**INDIANA
MICHIGAN
POWER**

March 18, 2005

AEP:NRC:5811
10 CFR 50.90

SUBJECT: Donald C. Cook Nuclear Plant Units 1 and 2
Docket Nos. 50-315 and 50-316
Partial Response to Request For Additional Information Regarding License
Amendment Request to Extend the Allowed Outage Times for Emergency Diesel
Generators, 69 kV Offsite Power Circuit, Component Cooling Water, and
Essential Service Water (TAC Nos. MC4525 and MC4526)

Figure 1

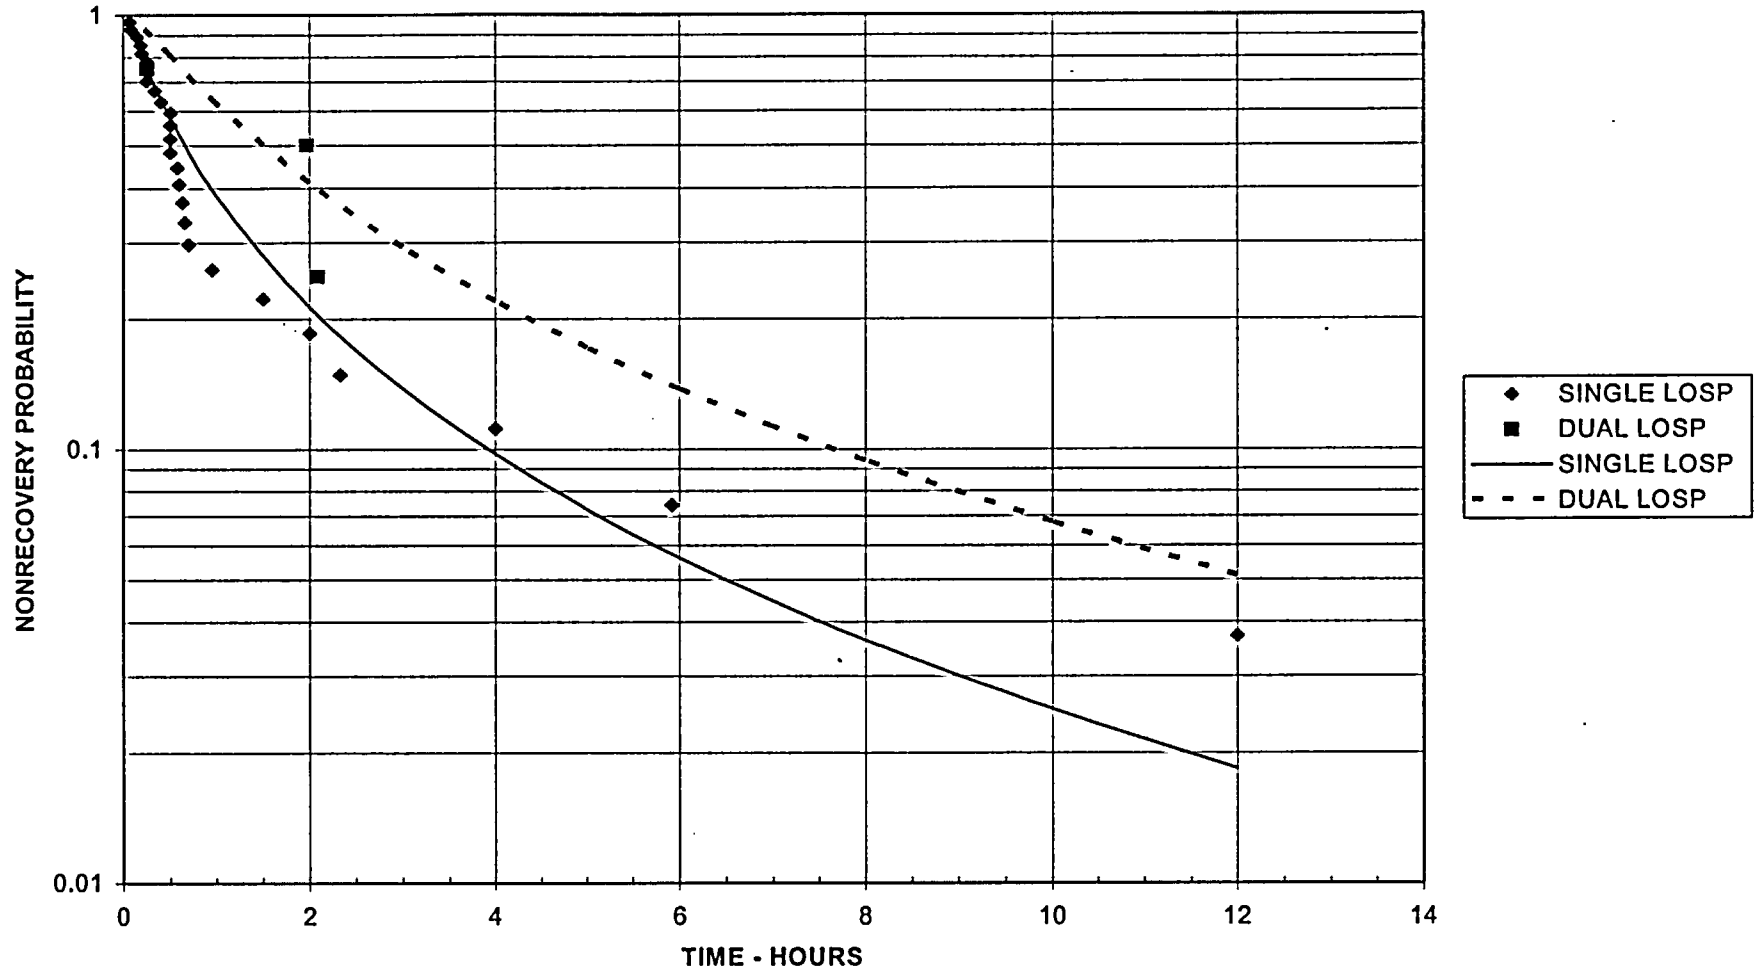
Discuss and provide information on the reliability and availability of offsite power sources relating to the proposed change. Provide the basis for the loss of offsite power (LOOP) frequencies and non-recovery probabilities used in the PRA models. Were they adjusted to reflect the Northeast blackout of August 2003? If not, why not? How is the potential for loss of offsite power given a non-LOOP initiating event (e.g., "consequential LOOP") modeled in the D. C. Cook PRA models? (RG 1.174, section 2.2.2; RG 1.177 Section 2.3)

Were they adjusted to reflect the Northeast blackout of August 2003? If not, why not?

This information is plotted in Figure 1 along with a lognormal fit to the data. The lognormal was chosen based on the analysis of Reference U10 [PRA-NB-ESW, "Essential Service Water System Notebook," Revision 2, Donald C. Cook Nuclear Plant, American Electric Power Nuclear Generating Group, October 2003]. This was done by operating on Ln [lognormal] (recovery time) using MS Excel. (See Reference U11 [PRA-NB-CCW, "Component Cooling Water System Notebook," Revision 2, Donald C. Cook Nuclear Plant, American Electric Power Nuclear Generating Group, October 2003]). First, the mean and standard deviation were determined and then the complementary cumulative probability (the probability of nonrecovery) was found. The parameters of the distributions are:

As can be seen from the data above and a review of Figure 1, there is very little data on recovery times for two unit stations, however the lognormal fit to the data tends to be conservative. Review of the above information and the information in Reference U10 indicates that a 50% increase in the mean single unit LOSP recovery time and a factor of 3 increase in the dual unit LOSP produces nonrecovery probabilities that could be considered as conservative estimates of the 95 percentile values. This information was then used to estimate the lognormal error factors in the table above.

The LOOP frequencies and non-recovery probabilities used in the PRA models to support the proposed amendment have not been adjusted to reflect the Northeast blackout of August 2003. A basis for not adjusting the LOOP frequencies and non-recovery probabilities is provided below.
